UNITED STATES PATENT AND TRADEMARK OFFICE

| APPLICATION NO. | FILING DATE | FIRST NAMED INVENTOR | ATTORNEY DOCKET NO. | CONFIRMATION NO. |
|--|-------------|----------------------|----------------------------|------------------|
| 10/587,152 | 07/25/2006 | Walter Stieglbauer | STIEGLBAUER ET AL 6 PCT | 4971 |

| Office Action Summary | Application No. | Applicant(s) | |

93DETAILED ACTION

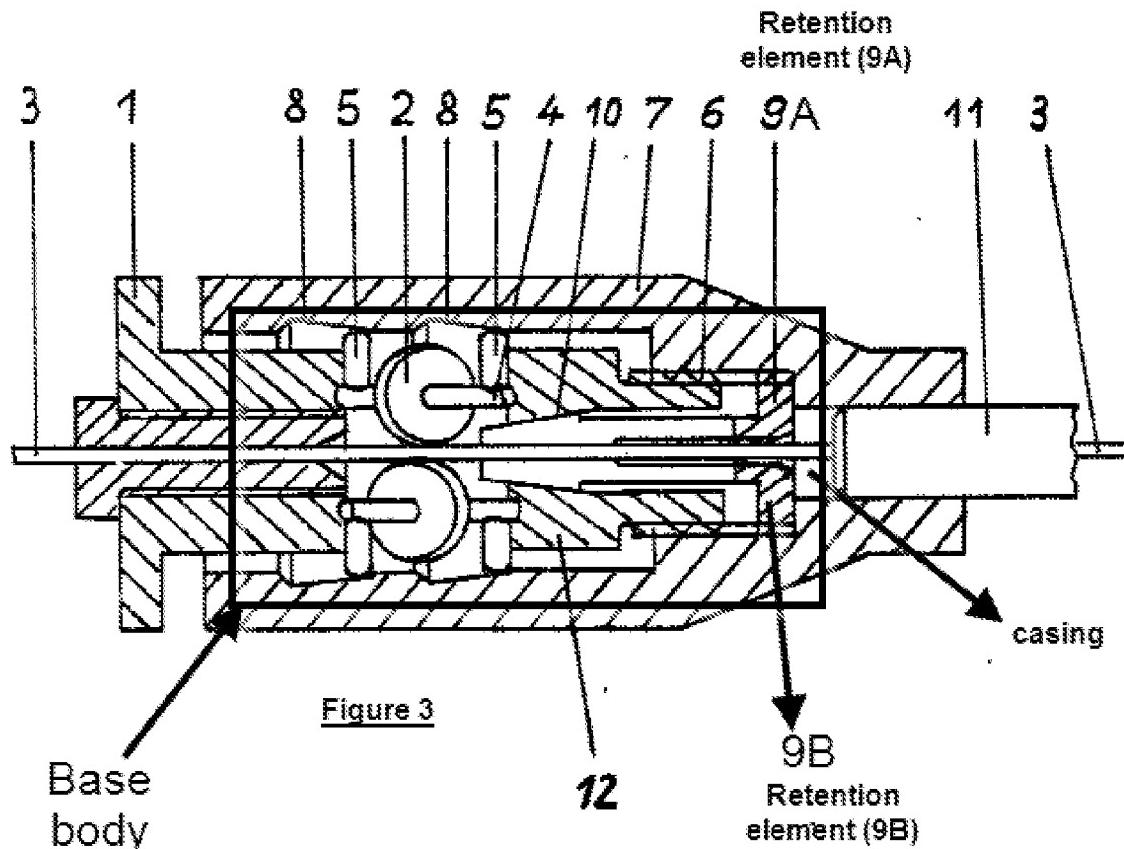
8. Regarding claim 45-49, 52-54, 56-58, and 60, Berger discloses a wire feed device, wherein the base body centrically (Page 1, lines 16-20) arranged in the drive sleeve 7 (Fig. 1); wherein the drive sleeve is formed with an internal thread adapted to the contour of the transport element 2 (Fig.1) and engaged by at least one transport element; wherein each of the internal thread of the drive sleeve, the base body (see figure below) and the guiding element conically designed 10 (Fig. 1) (Page 4, lines 28-

39); wherein the base body comprises a preferably cylindrical projection (Page 2, lines 10-14), wherein the cylindrical projection is mounted in the interior of the drive sleeve; wherein the base body , on its side located opposite the projection, comprises a rectangularly designed positioning flange 1 (Fig. 2); wherein the coupling element is directly connected with a drive, in particular electromotor (Page 4, lines 40-42); wherein the drive is arranged axially to the wire feed device (Page 3, lines 94-100); wherein the drive comprises a hollow shaft 11 (Fig. 11) (Page 4, lines 94-99), wherein the hollow shaft is connected with the coupling element wherein the welding wire 3 (fig. 1) is passable through the hollow shaft 11 (Fig. 11) to the wire feed device (abstract); wherein a pressure element is arranged in the base body so as to be positioned between the positioning flange (Page 2, lines 100-107) and the guiding element 5 (Fig. 1) and to exert a pressure force onto the guiding elements (Page 1, lines 79-89); wherein each guiding element 5 (Fig. 1) comprises a guide groove 8 (Fig. 1), and at least one guide pin is arranged on the base body to engage said guide groove of the guiding element (Page 1, lines 79-84); wherein each transport element is designed in the form of a ball (Page 3, lines 49- 56); and wherein the wire feed device is arranged in at least one of a welding apparatus (Page 1, lines 14-15).

9. Regarding claim 61, Berger discloses a method for feeding a welding wire 3 (Fig. 10 from a wire storage to a point of consumption, wherein a plurality of guiding elements 5 (Fig. 1) for guiding the welding wire 3 (fig. 1) are arranged in a base body (see figure 3 below), each guiding element including a guide path along which a plurality of transport elements 2 (Fig. 1) are displaceably mounted, wherein the guiding

However, Berger teaches wherein at least one guiding element is displaceably arranged in a base body (See “Base body” in figure 3 enclosed above); the positioning flange is connected with a retention element in a rotationally fast manner 9A (See Figure 3 enclosed above); wherein the drive sleeve is connected with a coupling element, coupling element being arranged on the opposite side of the retention element 9B (See Figure 3 enclosed above); wherein the drive is rotationally connected with a further retention element (See Figure 3 for retention elements); wherein the drive sleeve has an outer diameter of between 20 mm and 30 mm (Abstract, variable diameter). Therefore, it would have been obvious to one of ordinary skill in the art at the time of invention was made to modify the Berger’s reference, to include the above features. Berger was not adequately labeling those features on the figures and also his invention is capable of adapting them as well.
